**ON-SITE SEWAGE DISPOSAL SYSTEM
HOWARD COUNTY HEALTH DEPARTMENT
BUREAU OF ENVIRONMENTAL HEALTH**

SUBDIVISION: Haviland Hills

ADDRESS: 13837 Wayside Court

WALL CHECK
QIN RESIDENCE
HAVILAND HILLS
PLAT No. PB 10, P.34
LOT No. 25

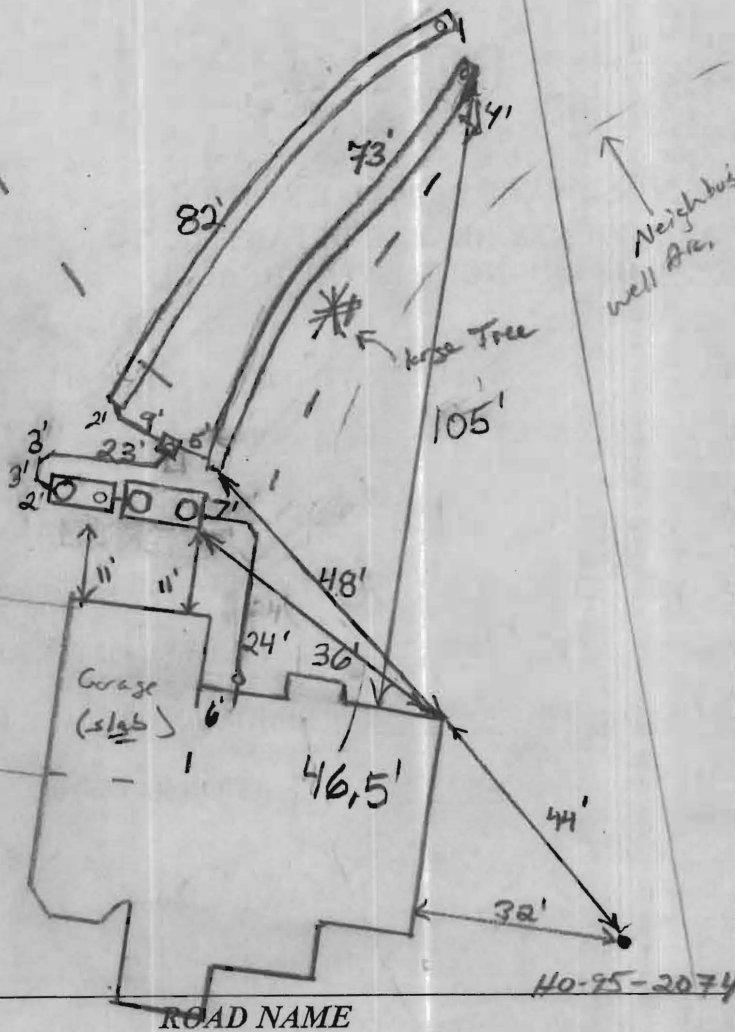
12/16/11 SBA slightly compacted. Fill on upper part of easement needs to be removed. System may need to be pumped. Remove fill and expose sewer out to street grades. (KW)

12/19/11 Shot grades. Fill removed from septic area. Pump tank will need to be installed. gravity will not be able to be made. 4 large trees to remain. Install a 72' trench on center @ top of SBA.

INSTALLATION: and an 82' trench just below it. (KW)

12/20/11 Both tanks set. Plumbing to tank. Need house connection. Top trench dug and being stored. OK to continue (KW)

12/22/2011 Need house connection and pump and alarm test. (BB)

1/4/2012 Pump and alarm working. (BB)
